# gpd Improved Compressor Design #6513010 '13-'16 Chevrolet Malibu 2.0L Turbo

**gpd #6513010  
with OE Mounting Bolt Holes for  
Heatshield**

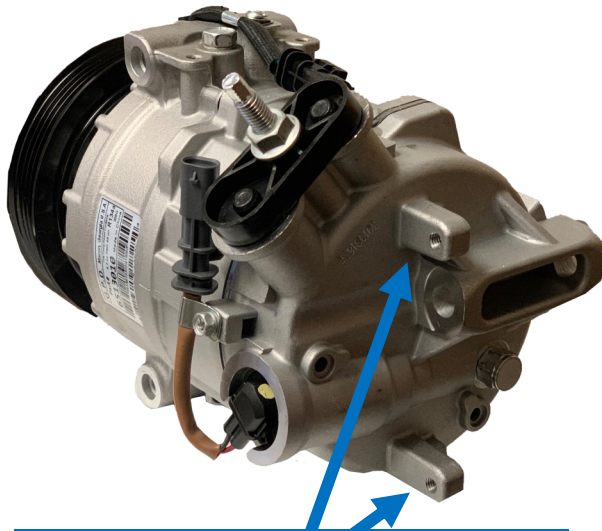
Some compressor replacements may be designed differently from the original equipment. For example, some compressor replacements for the 2013–2016 Chevrolet Malibu (2.0L Turbo) do not include mounting bolt holes on the head of the compressor.

The 2013–2016 Malibu 2.0L Turbo is designed with a heatshield (GM #22955225) behind the compressor. Without these mounts, the heatshield cannot be used. Because of the extra heat created from the turbo engine and proximity to the exhaust manifold, this may create problems and premature failure for the A/C system.

As your “Simple A/C Solution”, gpd has consolidated OE part numbers for compressor #6513010, to suit both turbo and non-turbo engines. This gpd compressor is also designed with OE style mounting bolt holes for proper function with the heatshield.
